UNITED STATES PATENT AND TRADEMARK OFFICE

APPLICATION NO.	FILING DATE	FIRST NAMED INVENTOR	ATTORNEY DOCKET NO.	CONFIRMATION NO.
10/517,883	12/29/2005	Michael Tittmann	502901-338PUS	1374

Office Action Summary	Application No. 10/517,883	Applicant(s) TITTMANN, MICHAEL	
	Examiner ATIF H. CHAUDRY	Art Unit 3753

DETAILED ACTION

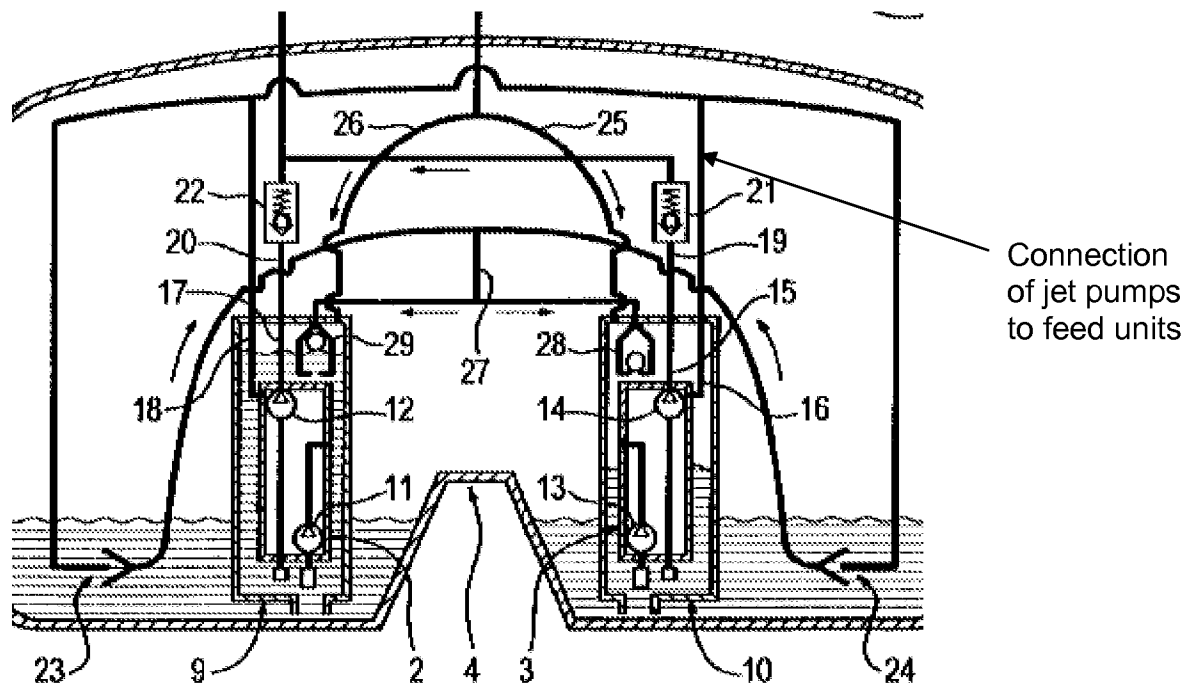
2. Claims 1-3, 5-7 and 9 are rejected under 35 U.S.C. 103(a) as being unpatentable over Sinz (US Patent 6276342) in view of Coha (US Patent 6553973).
3. Regarding claims 1 and 2, Sinz (fig. 1) discloses a fuel supply system for feeding fuel from a fuel tank 1 to an internal combustion engine 7 of a motor vehicle with a plurality of feed units 2, 3 arranged in the fuel tank 1, in which the feed units each have a surge chamber 9, 10 for collecting fuel and jet pumps 23, 24 for filling opposite surge chambers. Sinz fails to disclose a suction of a jet pump provided for filling a first surge chamber arranged in a second chamber. Coha (fig 1) teaches a fuel supply system comprising a saddle fuel tank and a plurality of surge chambers 69, 79 with the surge chamber 71 being fed by a suction line 74 connected to a jet pump 68 located inside a second surge chamber 69. It would have been obvious to a person having ordinary skill in the art at the time of the invention to have provided the fuel system disclosed by Sinz with a jet pump suction inside the surge chamber as taught by Coha in order to balance

the fuel level in the two chambers. Sinz discloses the fuel jet pumps at a minimum designated height in the tanks and it have been obvious that when placed inside the surge tanks the suction inlet of the jet pumps would be at a designated minimum height in the surge tanks. Moreover, all jet pumps stop pumping fluid when the filling level drops below the suction inlet of the jet pump.
